STAFF RECOMMENDATION

302 Chapel Avenue

February 20, 2019

Application: Demolition—Partial; New Construction—Addition and Outbuilding

H0.1

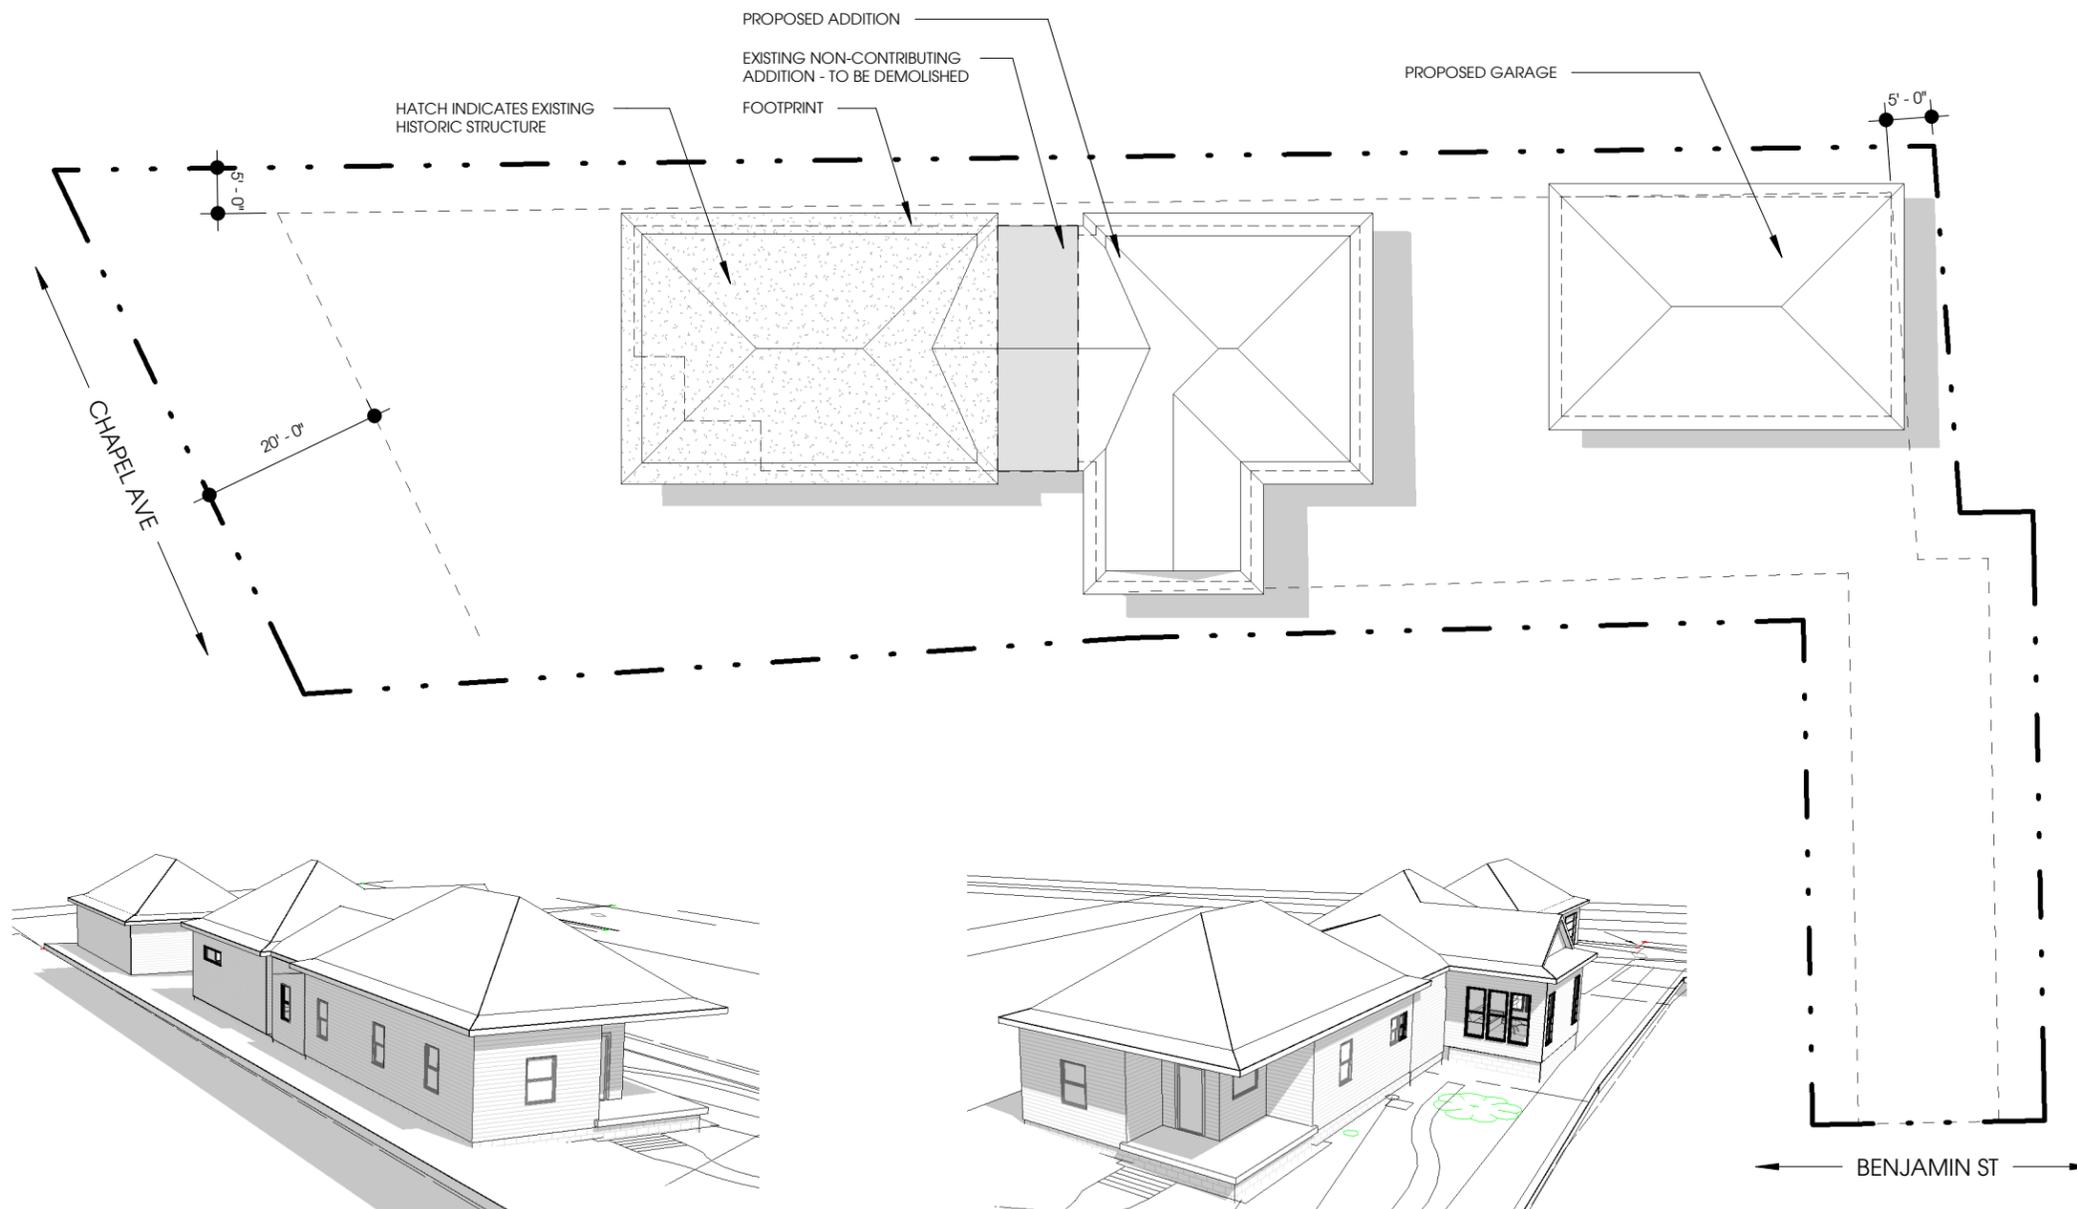
MINIMUM	PROPOSED
Space between principal building and Garage	20'	17'-8"
Rear setback	5'	5'
L side setback**	5'	5'
R side setback**	5'	17'
How is the building accessed?	Unique Lot Shape, Driveway from Benjamin Street

Although the outbuilding is less than twenty feet (20') from the house, Staff finds the location to be appropriate because the distance of seventeen feet (17') is minimally different than what is required. The purpose of the distance is to prevent large additions that are essentially attached to garages resulting in a build-out of the entire lot. In this case, the proposed addition is minimal and remains at one-story, the outbuilding is less than the maximum allowed and portion of the lot is too narrow to be built on. Staff finds that the outbuilding's massing meets section II.B.1.h.1 of the design guidelines.

H1.0

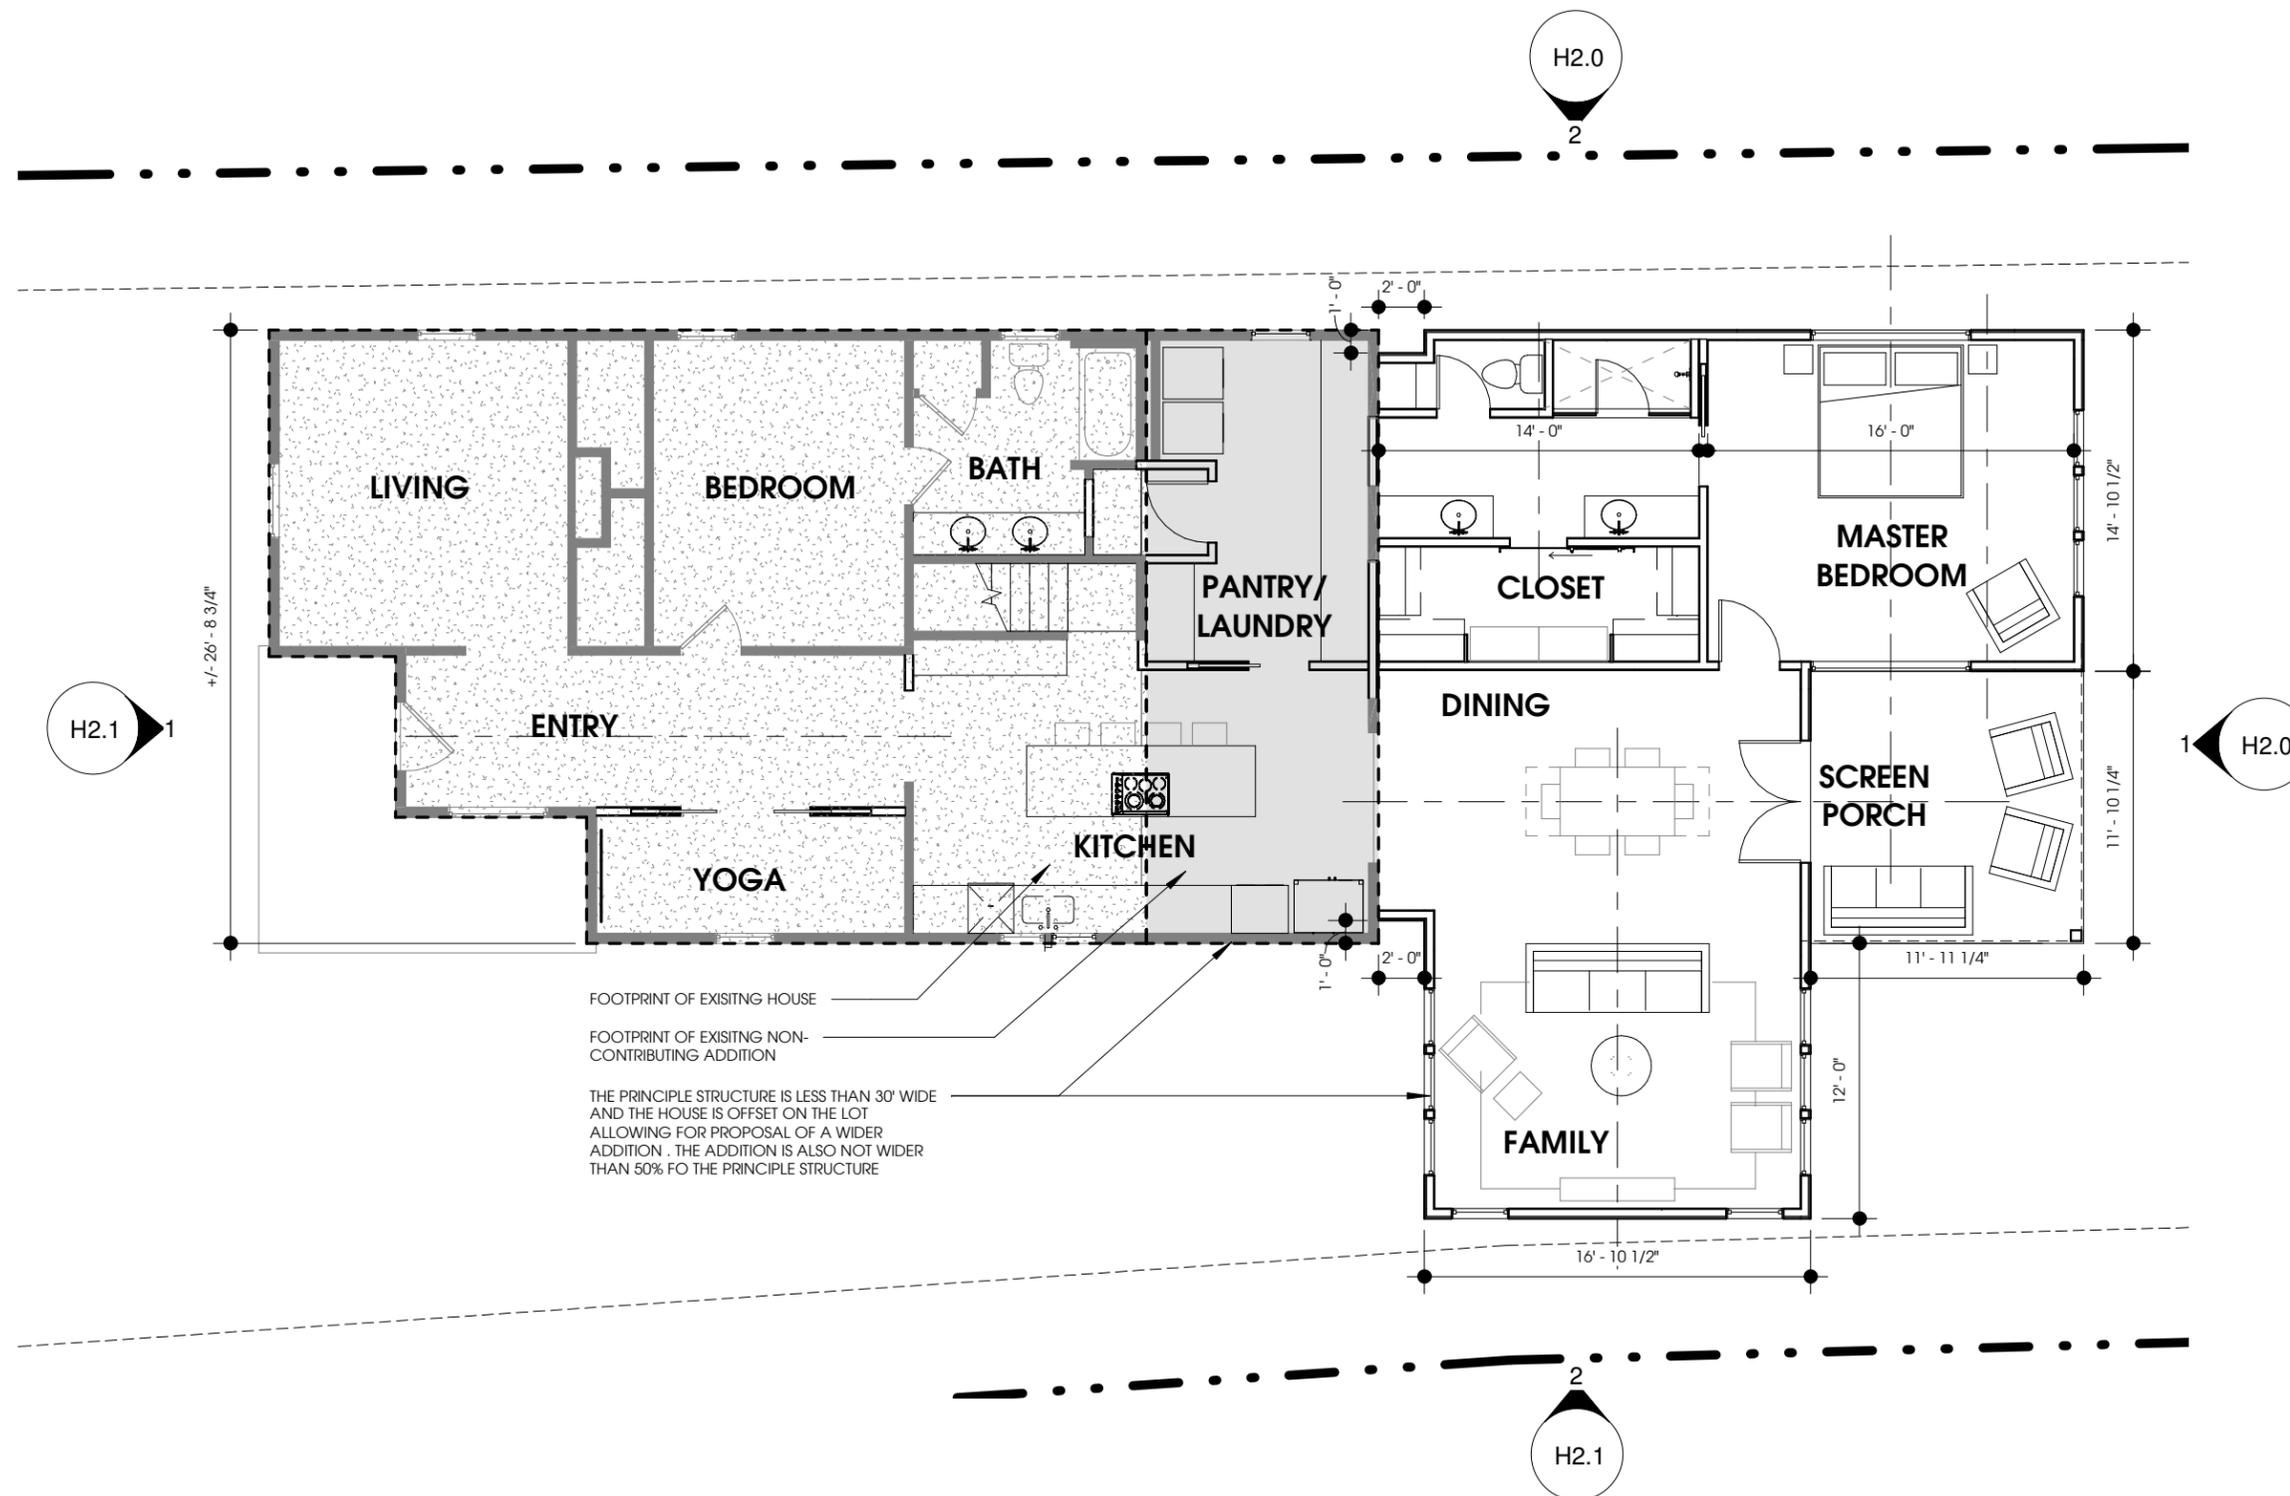
Location & Removability: The new addition will attach to the historic house at the rear corners of the historic building. Additions are generally required to step in from the sides of an historic house to retain the original form and preserve historic materials, however the form and materials at the rear of the historic building have already been altered because the existing addition is not stepped in, therefore Staff finds that it is necessary for the proposed addition to not step in at this location.

The addition will then continue thirty feet (30') toward the rear, beginning with a two foot (2') wide alcove stepped in one foot (1') from the primary wall. By stepping in from the roof and walls before extending further to the rear, the addition will not impact the front or side facades of the historic house and would not further impair the house's historic integrity. Staff finds that the location and attachment of the addition is appropriate and meets section II.B.2.a and II.B.2.d of the design guidelines.

The depth of the original house is thirty-eight feet (38') and the existing addition is ten feet (10') deep. The new addition will increase the depth of the house by thirty feet (30'). Roughly half of the new addition will be wider than the historic house, extending twelve feet (12') to the right. It is generally not appropriate for additions to be wider than an historic house, however the design guidelines allow wider additions on houses that are less than thirty feet (30') wide or the house is shifted to one side of the lot. Staff finds the proposed addition width to be appropriate because the house is only twenty-eight feet (28') and the house is shifted to one side of the lot. Furthermore, Staff finds the additional width of the addition to be appropriate because it is less than half of the width of the historic house and it is only one story.

Setback & Rhythm of Spacing: The proposed addition will not increase the width of the house to the left, and will have a narrow hyphen before going wider to the right. Despite the additional width, Staff finds that the addition will not disrupt the established rhythm of spacing along the street because the additional width is so far to the rear and because the historic house is currently shifted far to the left side of the lot. Additionally, while the lot has fifty feet (50') of street frontage, the lot lines are angled making it roughly forty feet (40') wide at the widest point of the addition, and the addition would still meet the five foot (5') left and right side setback requirements.

Proportion and Rhythm of Openings: A new window will be added on the right side of the original structure toward the rear, adjacent to an existing window of the same size. This section of the right façade wall may have already been altered as the existing window size is shorter than is typical for this type and style of house. No other changes to the window and door openings on the existing house were indicated on the plans.

H2.1

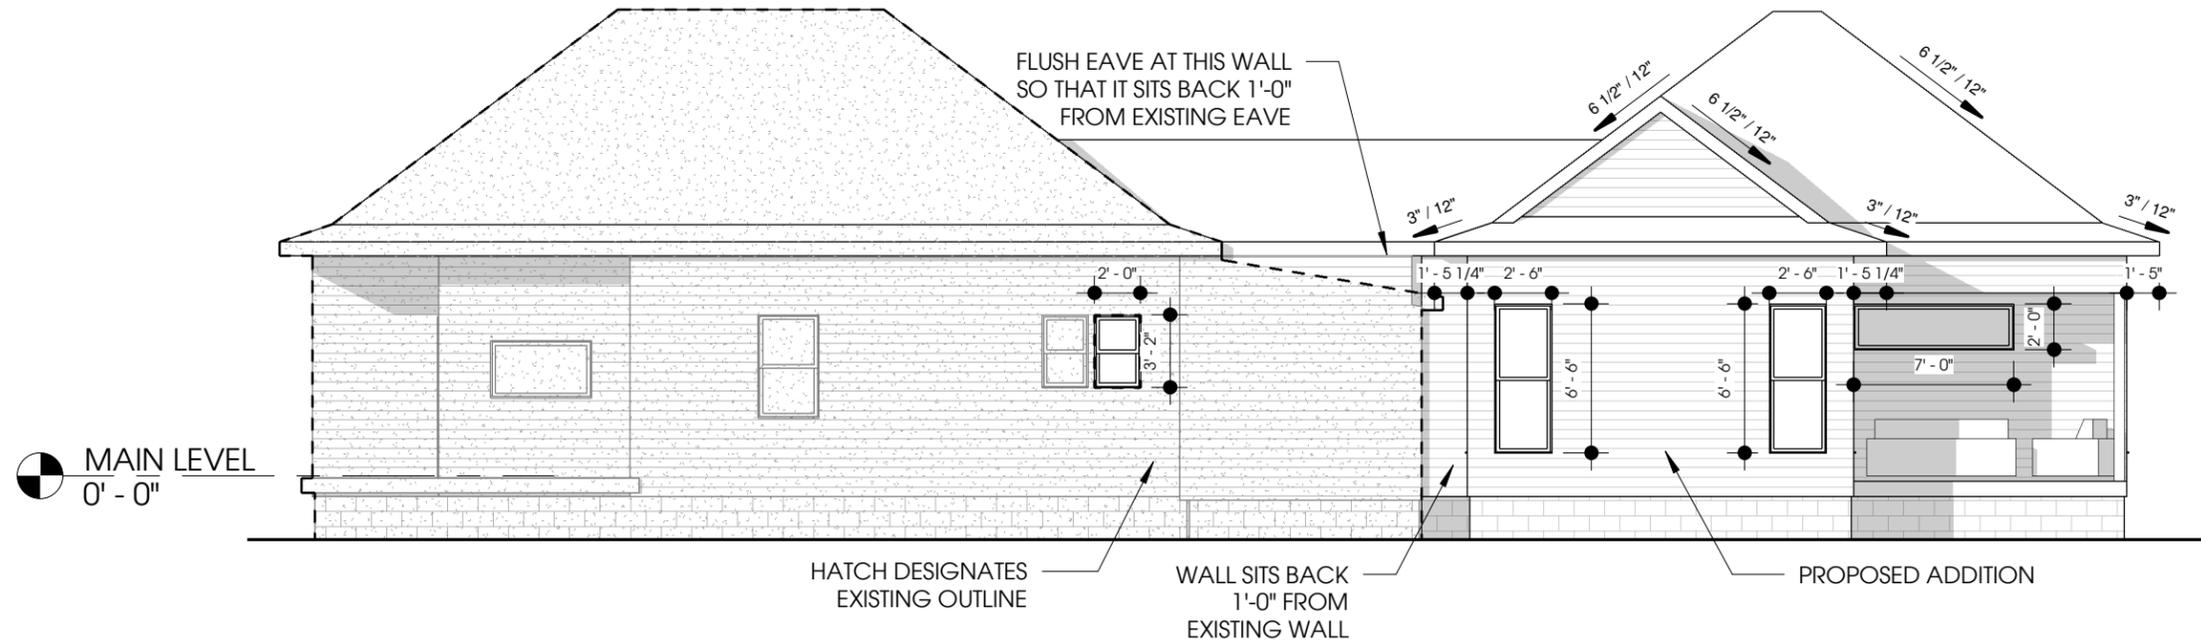
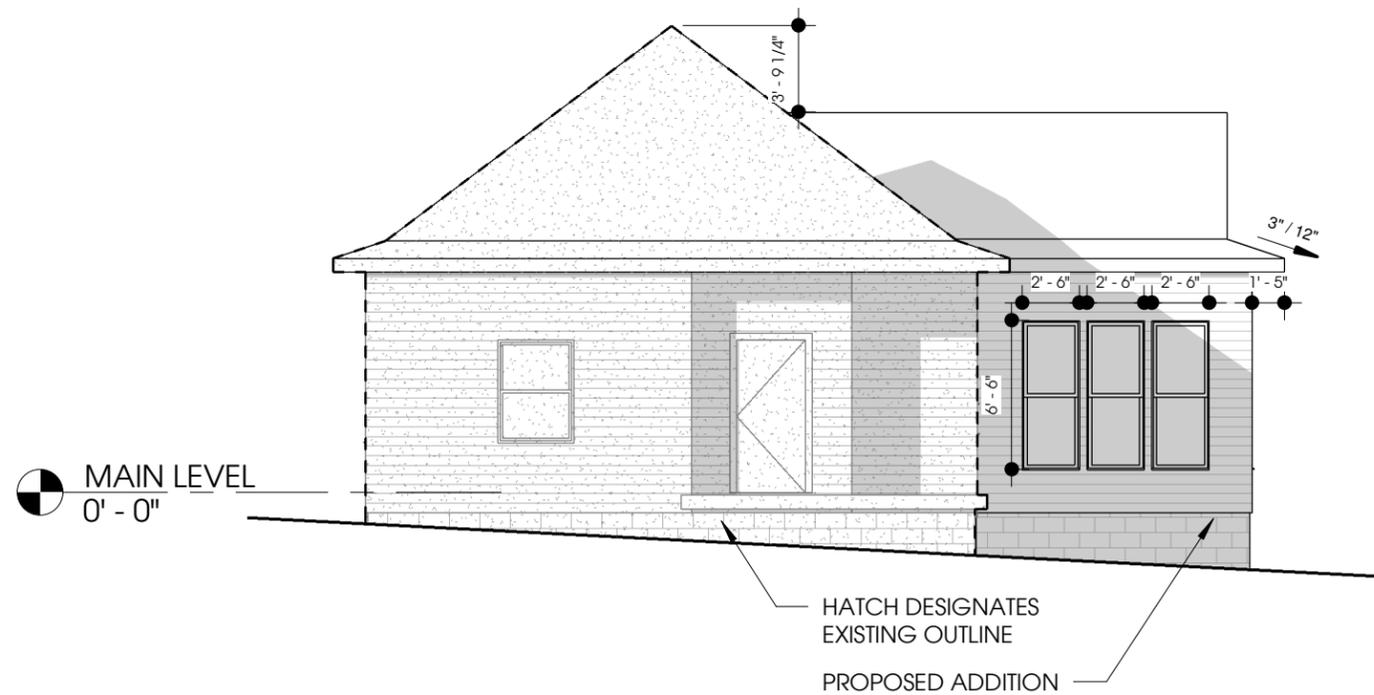
The left side of the addition is shown with a section of wall without any windows, and with a horizontally oriented window that is more than three times wider than it is tall. Typically, windows on Folk Victorian house are twice as tall as they are wide and are spaced with no more than ten to twelve feet (10' to 12') between openings. With the condition that a window is added on the left side of the addition and that the windows on the left side are more vertically oriented, Staff finds that the project's proportion and rhythm of openings are appropriate and meet section II.B.1.g of the design guidelines.

1. Window selections shall be administratively approved prior to installation; and
2. An additional window shall be added on the left side and the windows on the left side shall be more vertically oriented; and,
3. The HVAC shall be located behind the house or on either side, beyond the mid-point of the house.
